Product Change Notification / GBNG-08VOOS770

CCB 4131.001 Final Notice: Qualification of MTAI as a new assembly site for selected PIC24FJ128GL305 and PIC24FJ64GL305 device families available in 48L TQFP (7x7x1mm) package.

Description of Change: Qualification of MTAI as a new assembly site for selected PIC24FJ128GL305 and PIC24FJ64GL305 device families available in 48L TQFP (7x7x1mm) package.

Lead Frame Comparison

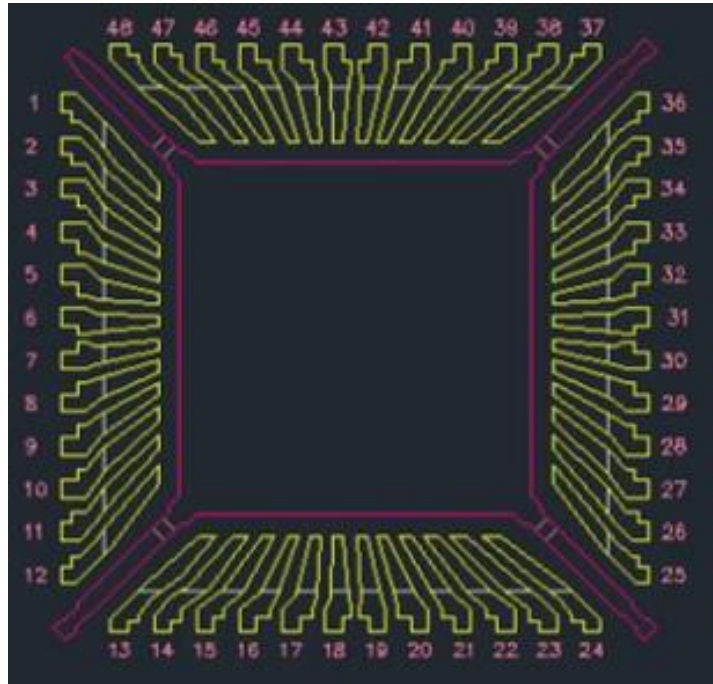
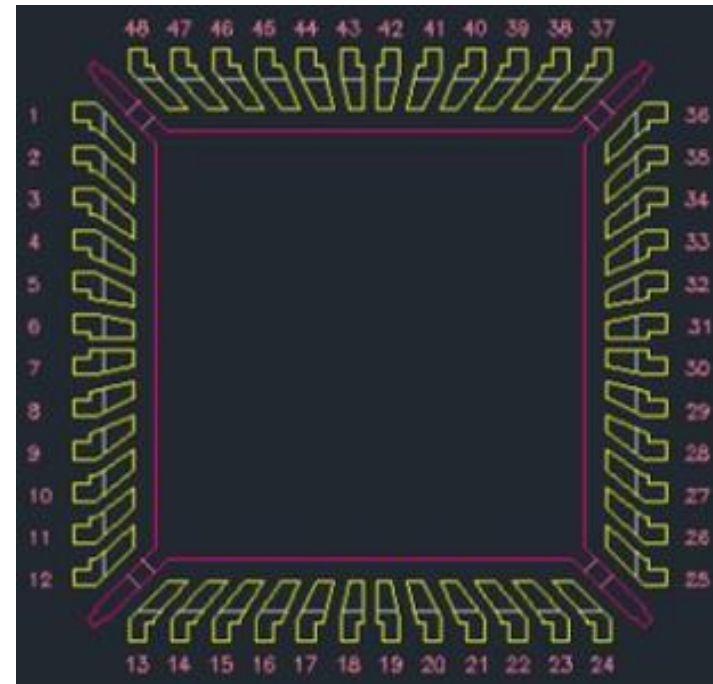
Assembled at ANAP assembly site with MSL 3 classification using AP4200 die attach, G631HQ mold compound, C194 lead frame, 161x161 mils paddle size.

Assembled at MTAI assembly site with MSL 1 classification using 3280 die attach, G700HA mold compound, C7025 lead frame, 200x200 mils paddle size.

Pre Change	Post Change
Assembly Site	Amkor Technology Philippine (P1/P2), INC. / (ANAP)	Microchip Technology Thailand (HQ) (MTAI)
Wire material	Au	Au
Die attach material	AP4200	3280
Molding compound material	G631HQ	G700HA
Lead frame	Material	C194
	Paddle size	161x161 mils
	Design	Please see attached Pre and Post Change summary.
MSL Classification	MSL 3	MSL 1
